Item 4.**Development Application: 224-234 Young Street, Waterloo - D/2025/944****File Number:** D/2025/944**Summary****Date of Submission:** 1 October 2025. Amended plans received on 9 April 2026.**Applicant:** The Living Company**Architect/Designer:** Architecture AND**Owner:** Majesty Properties Pty Ltd**Planning Consultant:** Beam Planning**Cost of Works:** \$71,667,732

Proposal Summary: The proposal seeks consent for the demolition of existing site structures and the construction of a 7 storey co-living development including a ground level retail use. The proposed co-living component includes 283 residential rooms with a total capacity of 333 occupants.

Figure 27: illustrates the sites indicative built form and height in storeys. (X) heights in brackets represent heights before design excellence and competitive design process.

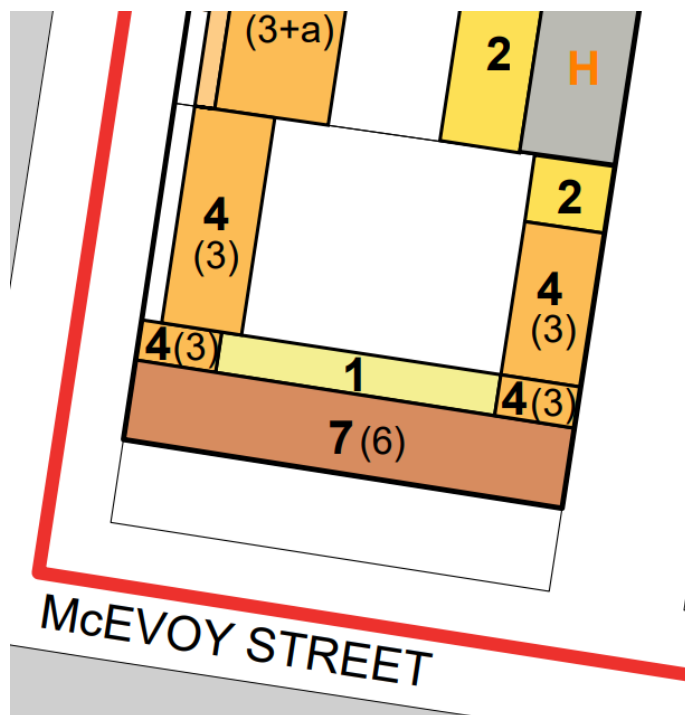
84. Section 5.9 of the Sydney DCP 2012 provides objectives and provisions for development sites located in the Danks Street South precinct.
85. Figure 5.245 of the DCP identifies the site's prescribed height in storeys, subject to a competitive design process. Without a competitive design process, the site is prescribed a part 2, 3 and 6 storey development. Alternatively, the site can achieve a part 2, 4, 7 storey development with a design competition.

86. The proposed development, which has been amended following consultation with council staff and the Design Advisory Panel, seeks a part 2, 5, 7 storey development, as illustrated below. This results in a departure to the prescribed height in storeys.

Figure 29: Variable range of maximum height of building development standards for the site

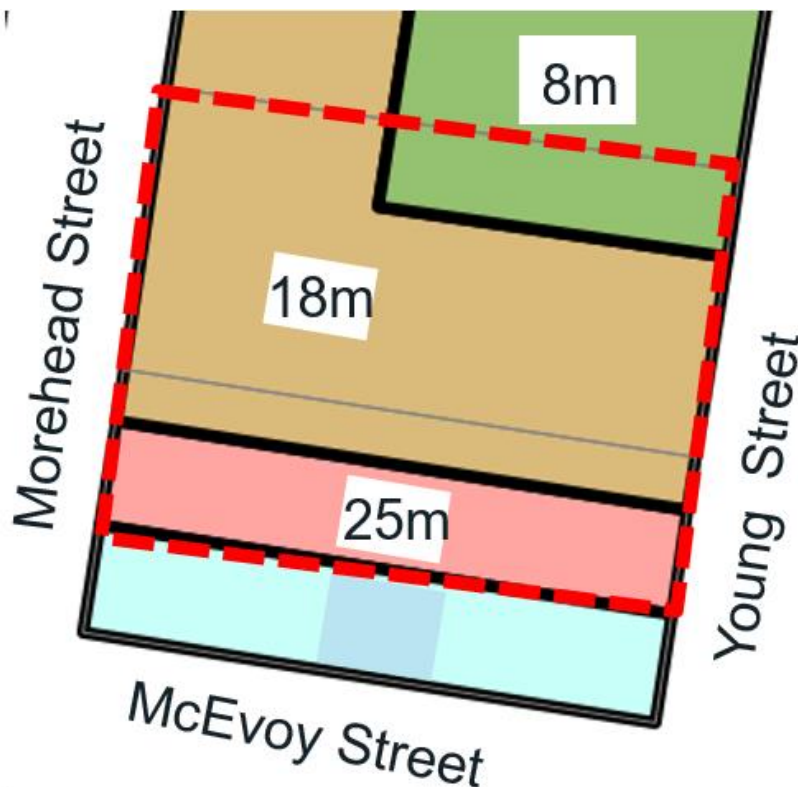
92. The site is subject to a variable maximum height of building development standards, between 8m, 18m and 25m, as illustrated below.

93. The proposed development has a maximum building height of 26.35m, and the following variations to the height of building development standards are proposed:
 - McEvoy Street: 1.3m (5.4%) height variation to the 25m height limit. The elements of the building which exceed the 25m height limit include portions of the roof on the southern portion of the building.
 - Morehead Street: 1.9m (10.55%) height variation to the 18m height limit. The elements of the building which exceed the 18m height limit include communal rooftop open space and parts of the parapet.
 - Young Street: 1.47m (8.17%) height variation to the 18m height limit. The elements of the building which exceed the 18m height limit include communal rooftop open space and parts of the parapet.

Figure 31: Cross viewing diagram (provided by applicant)

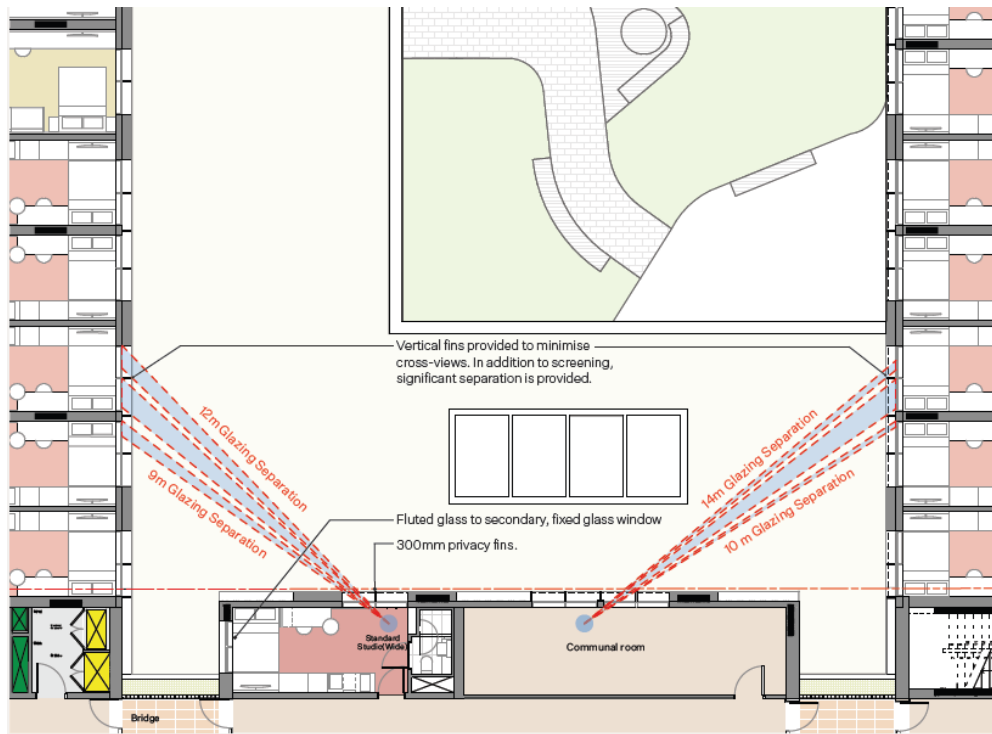
- 110. It is also recommended that the western window of the Standard Studio (Wide) vertical stack of rooms facing north is to be amended to fluted glass for privacy.

- 111. The above conditions are intended to limit cross viewing whilst maintaining adequate outlook for all units.
